Ten feet is a sensible target—not yet a proven fit.

Codex design analysis | September 25, 2026 | Dimensions are drawing/model based, not field verified. Not for construction.

Current model footprint / 60" table / assumed 18" occupied-chair band

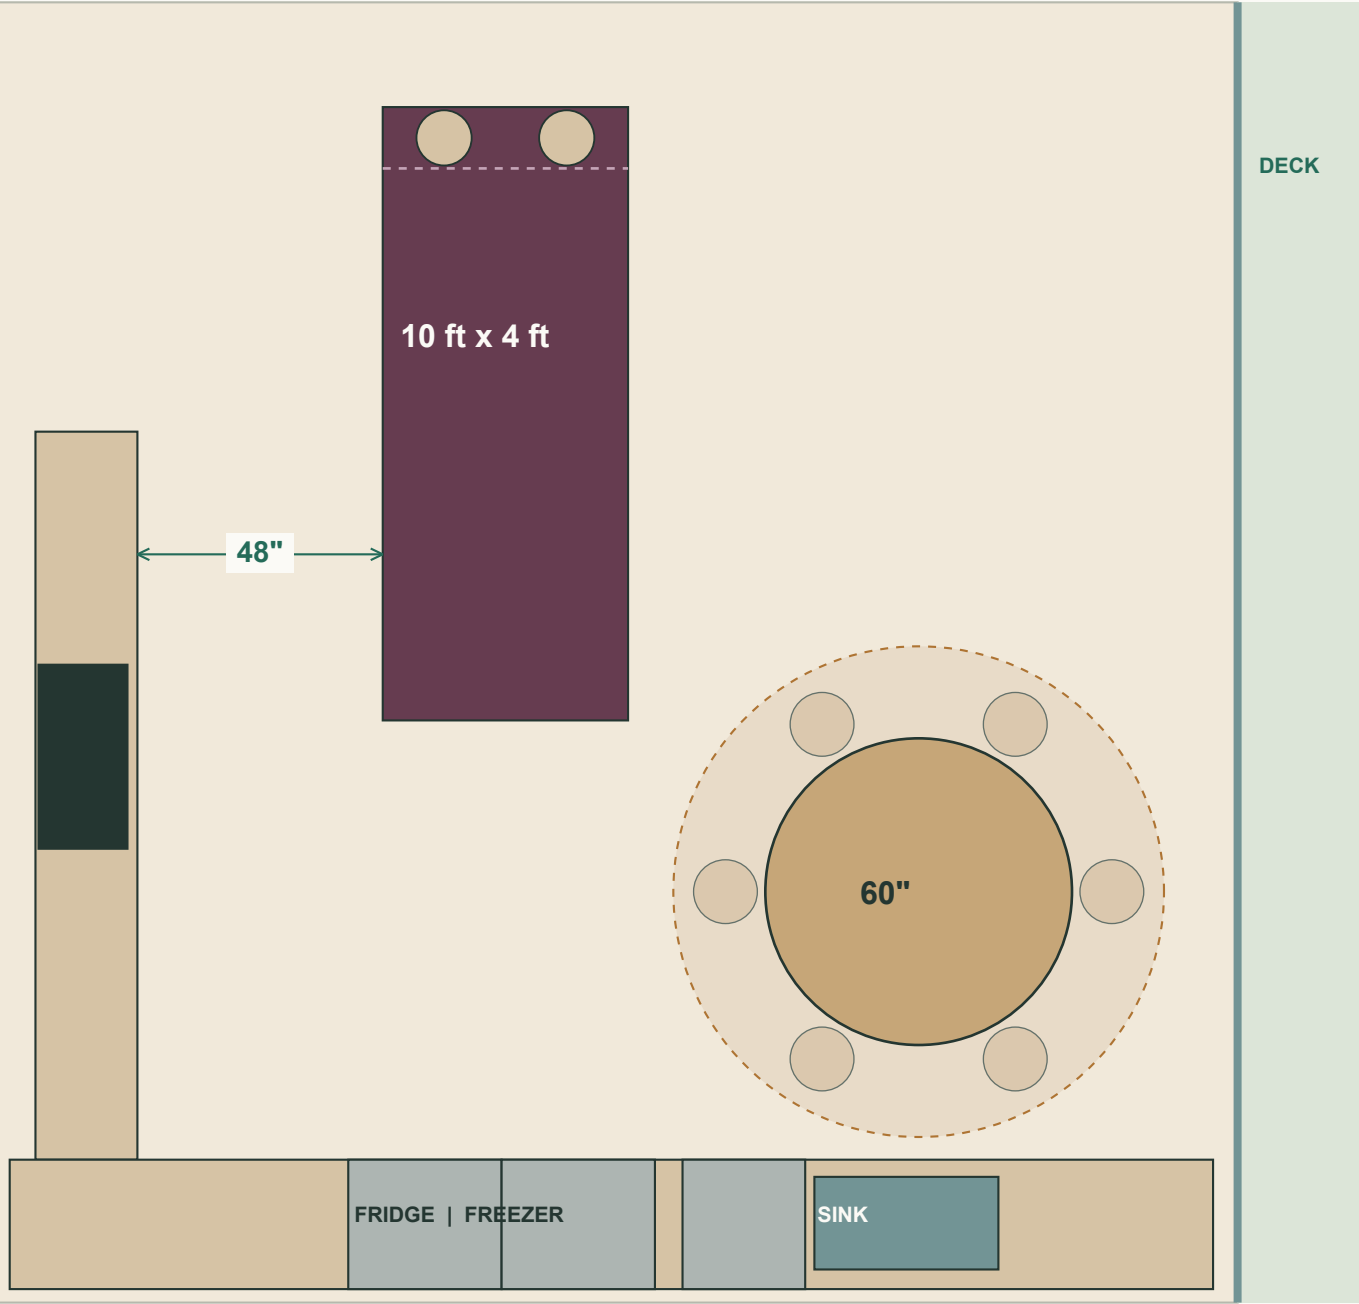
At the 60-inch table, the nominal edge-to-sink-counter gap is only 22.4 inches; edge-to-deck room line is 32.4 inches. Chairs make both tighter. Shortening only the island cannot fix those two distances.

Keep 10 feet as the upper target while the cabinet plan is resolved. Test a 54-inch table first. If six occupied chairs plus easy sink/deck movement are non-negotiable, compare a 9-foot island; do not approve cabinetry from the current model.

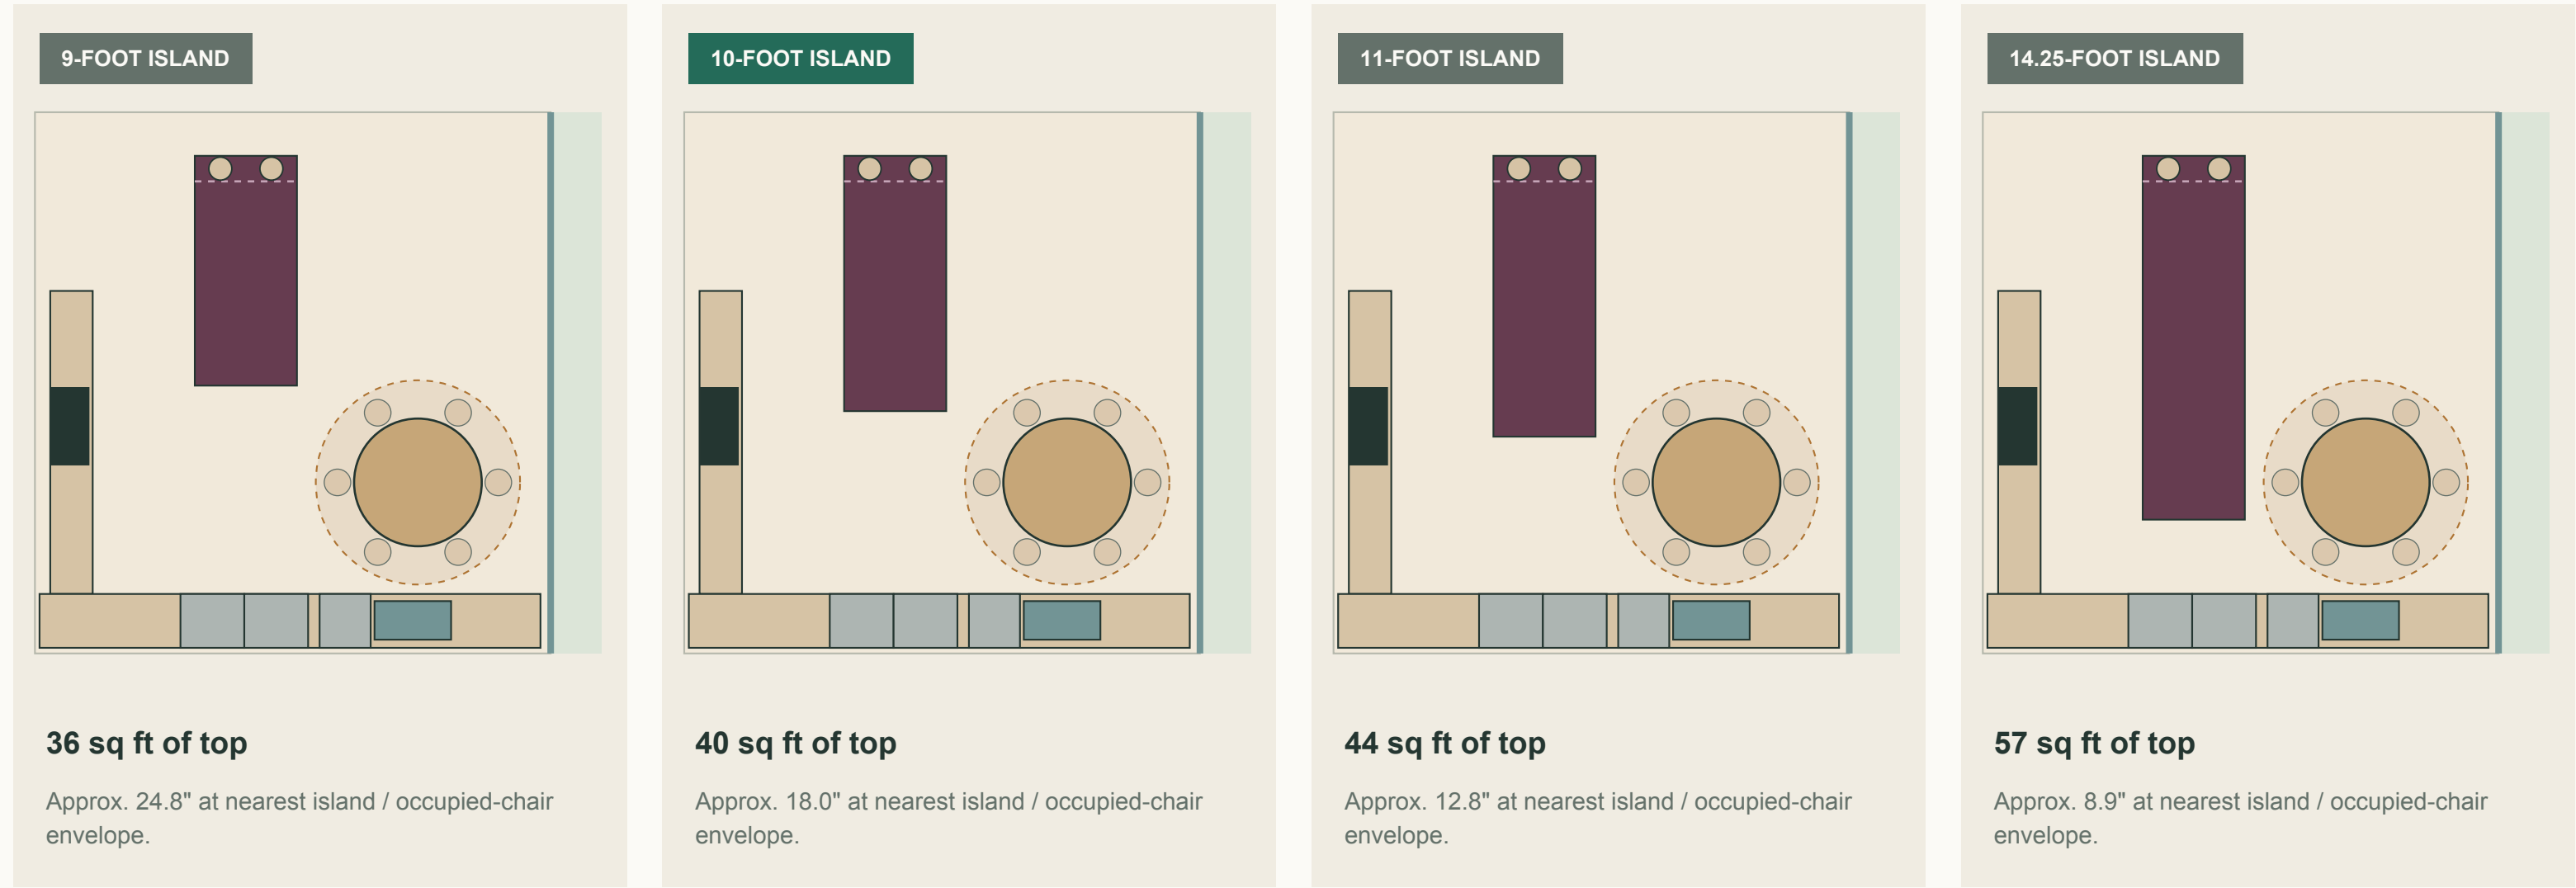
Same living-facing end, same 4-foot width, same 60-inch table center. Shortening occurs at the table end, as in the current model.

LENGTH	FIT CONSEQUENCE	READING FOR YOUR BRIEF
9 ft	Adds 12" longitudinal space at table end; 36 sq ft top	Useful fallback if the occupied-table mockup makes 10 ft feel crowded.
10 ft	40 sq ft top; current intended size	Good prep/storage provision, but table/sink pinch still unresolved.
11–14¼ ft	More top; progressively less table-end relief	Little support in your two-stool brief; not my recommendation.

CURRENT / 60"

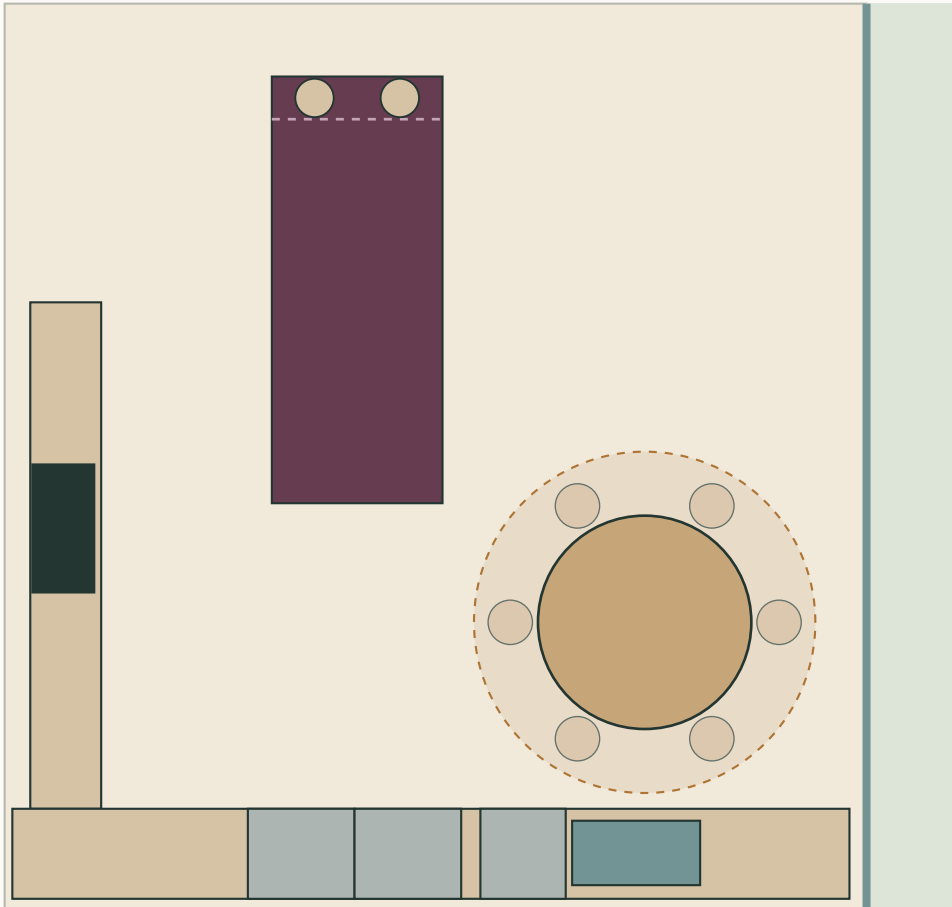
EDGE TO...	NOMINAL GAP
Deck room line	32.4"
Sink counter	22.4"
Nearest island corner	36.0"

TEST / 54", REPOSITIONED

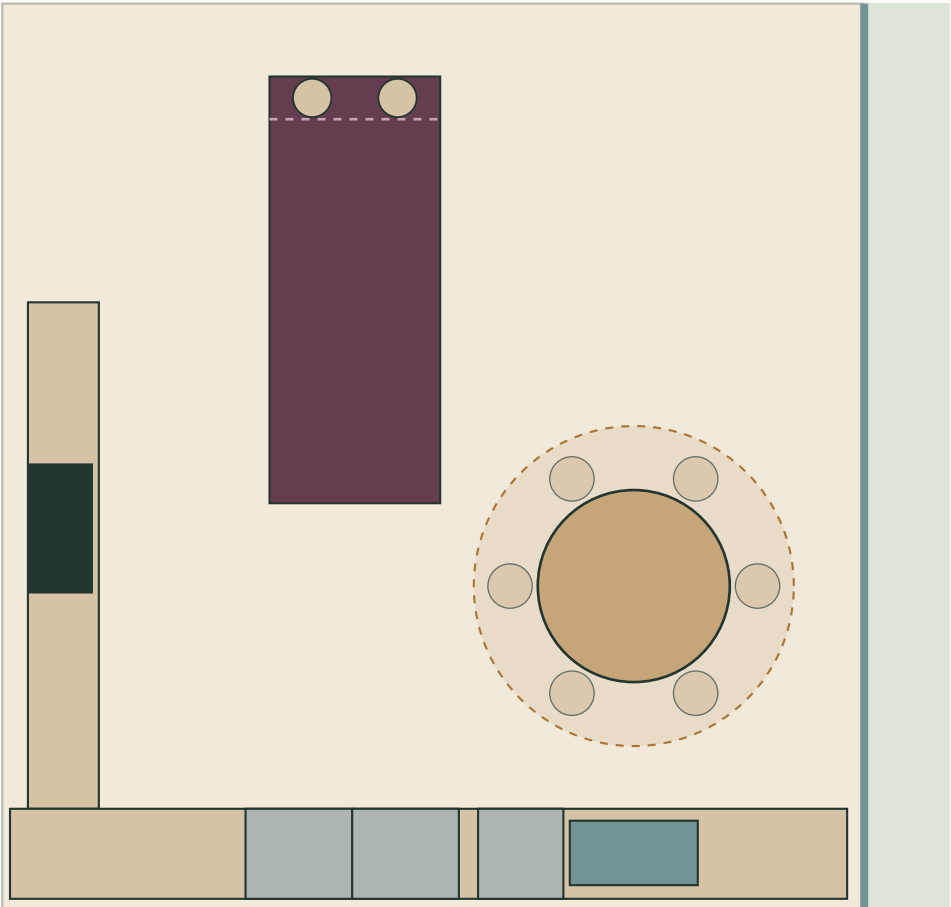
EDGE TO...	NOMINAL GAP
Deck room line	37.8"
Sink counter	35.6"
Nearest island corner	32.2"

The 54-inch test is more balanced

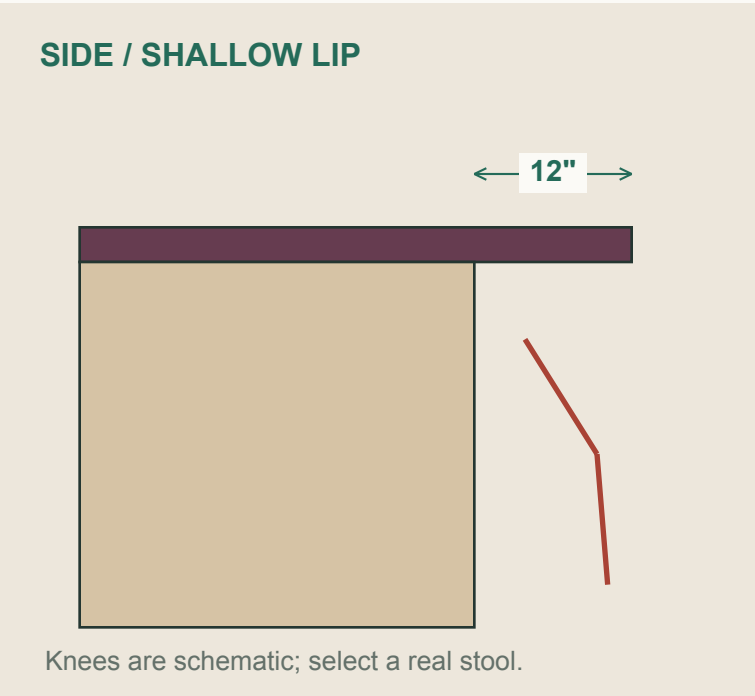
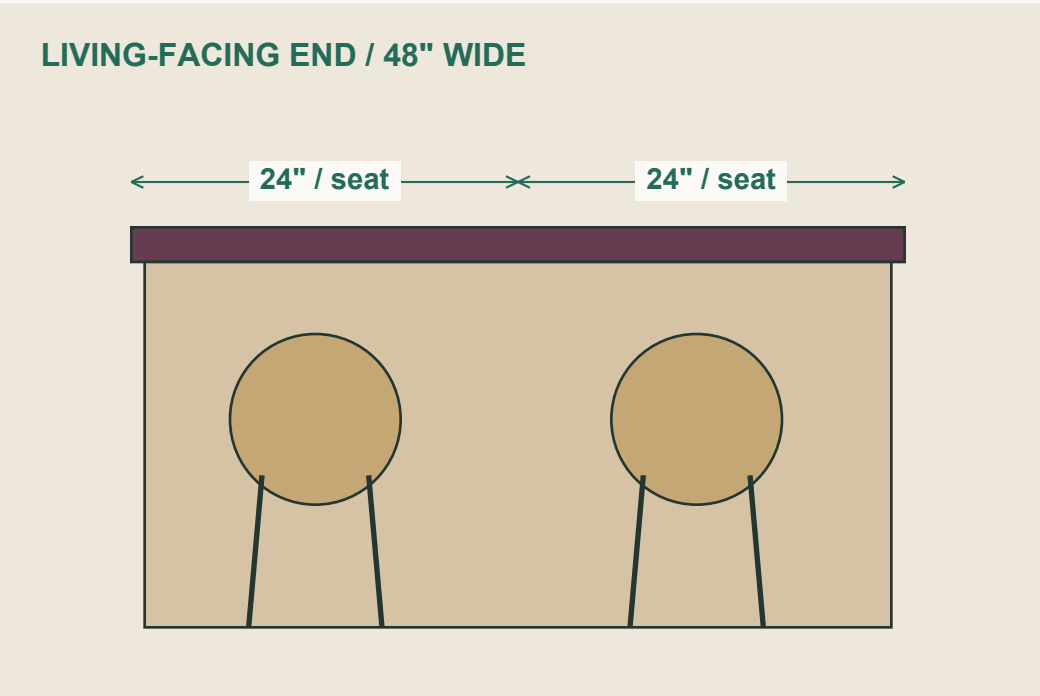
Moving the table 2.4 inches away from the deck and 10.2 inches toward the living room gives roughly 32–38 inches to nearby boundaries. That is seating space, not a generous route behind every diner.
